Historic District Commission

AGENDA

Wednesday, January 15, 2020

COA-2014-07, Modification #2 – 37 Mechanic Street – The Community Kitchen

② Proposed solar array

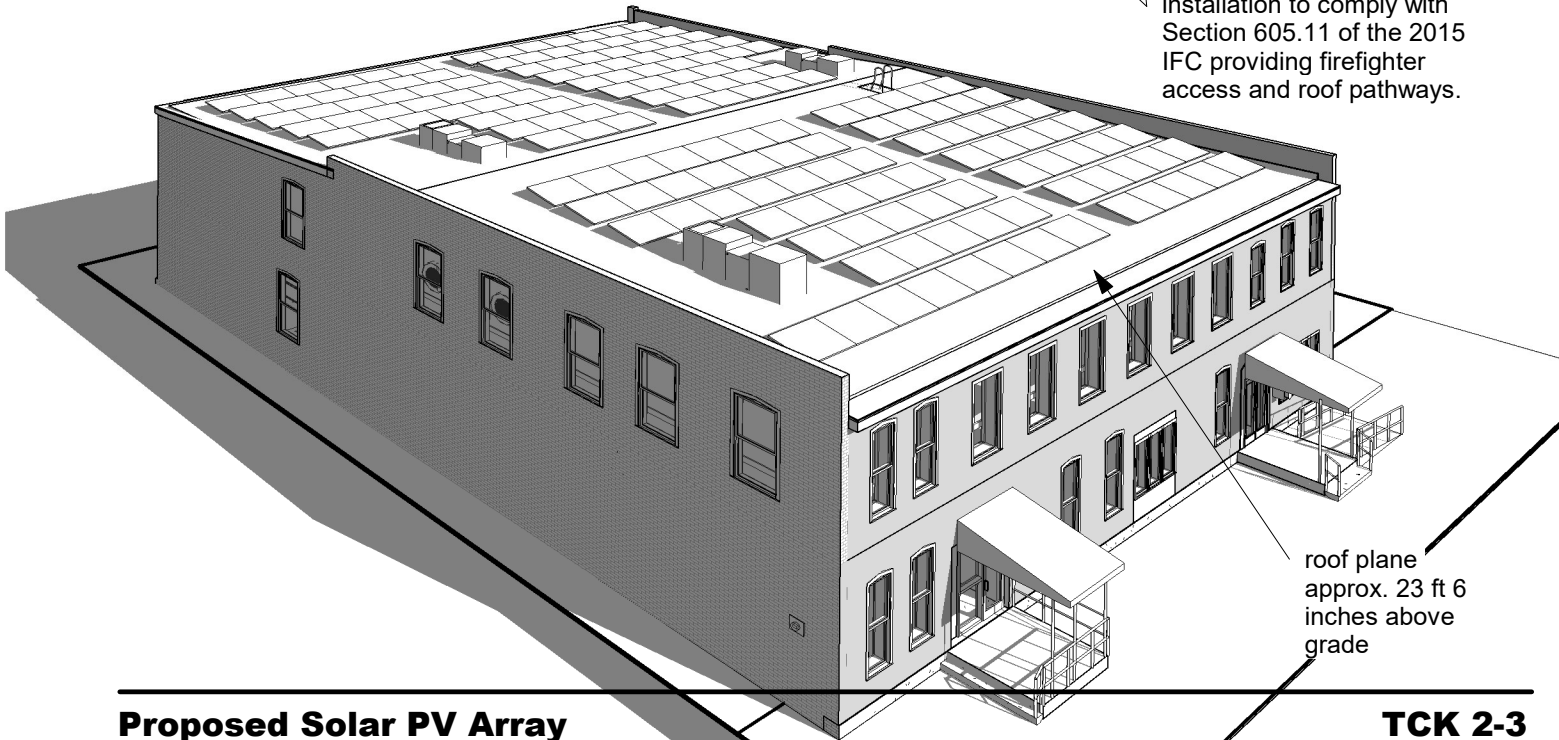
The applicant proposes to install a solar photovoltaic system on the flat roof of the primary structure, as shown in the rooftop plan and rendering attached to this staff report. This location appears to be the preferred location on the site because the rear of the property is visible from Pleasant Street, there are no accessory buildings that would be suitable for a solar PV array of the appropriate size, and there are no new additions to the building. This standard appears to be met.

Based on initial plans, the applicant intends to install a rooftop solar PV system that is roughly rectangular, with setbacks from the roof and access aisles as required by the Fire Code. The entire system will be on the same roof plane. The Board may wish to include staff approval of the solar array grid as a condition of approval for this project to ensure that the grid array is regular in shape and jointed.

Figure 2 (Left): The window jamb on the main façade requiring minor masonry repair. Figure 3 (Right): The brick that will be used in masonry repairs, if the original bricks cannot be reused.

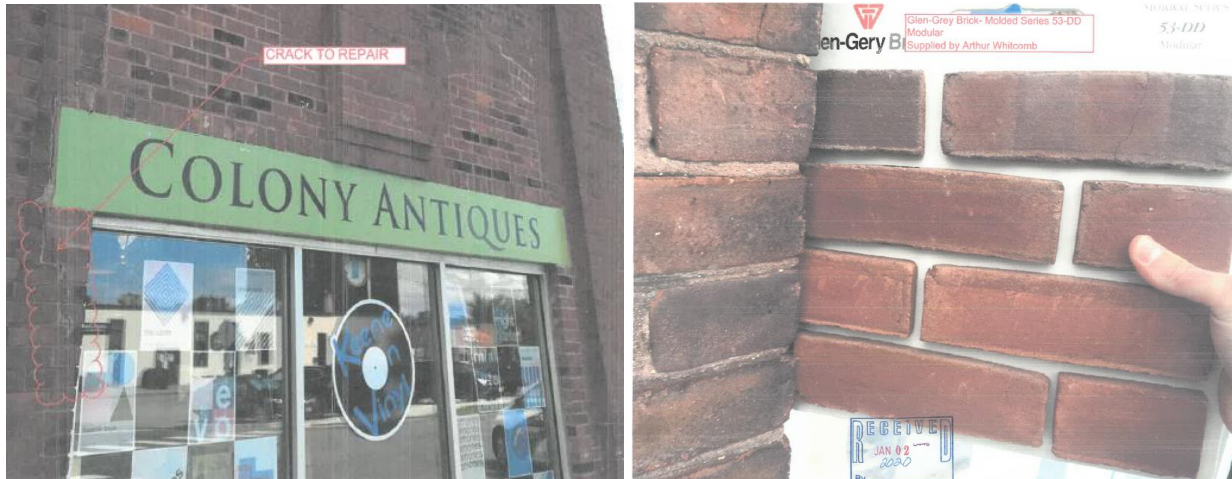
The applicant proposes to replace the existing masonry window jamb on the front façade of the building which, according to an engineer, has settled and is structurally unstable (See Figures 2 and 3). The masonry would need to be rebuilt from the lintel to the foundation. The applicant proposes to match the existing mortar and reuse existing bricks, if possible. The photos below show the area of masonry to be repaired, as well as the bricks to be used, if the original bricks cannot be salvaged during repairs. The proposed brick replacement product has been identified as “Glen-Gery Brick – Molded Series 53-DD.” At the time of this staff report, material samples showing the color, profile, width, and composition of mortar to be used have not been submitted. The applicant is hoping to have samples ready in time for the meeting and is not proposing to clean the masonry prior to repairs. If the applicant is unable to bring a mortar sample to the meeting, the Board may wish to include staff approval of the mortar type and a test patch prior to brick repointing as conditions of approval.

5 APPROXIMATE PROPOSED SITE PLAN
NOT SURVEYED SCALE: 1/16" = 1'-0"

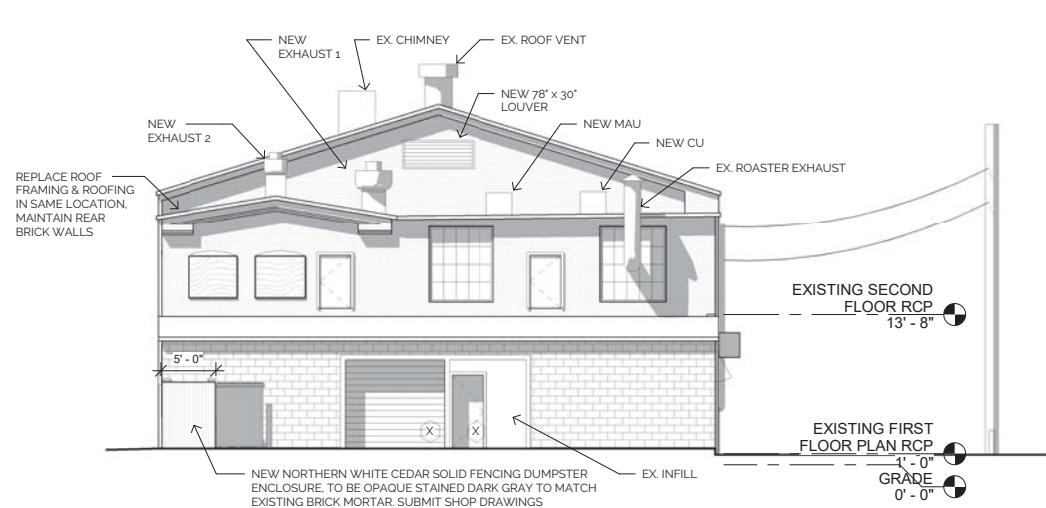
The applicant proposes to place a dumpster at the rear of the building, repair an existing masonry window jamb on the primary façade facing Emerald Street, and replace the rear roof structure and rooftop mechanical equipment. In addition, the applicant proposes to uncover and rehabilitate existing windows on the first floor, as well as relocate a window from one existing opening to another.
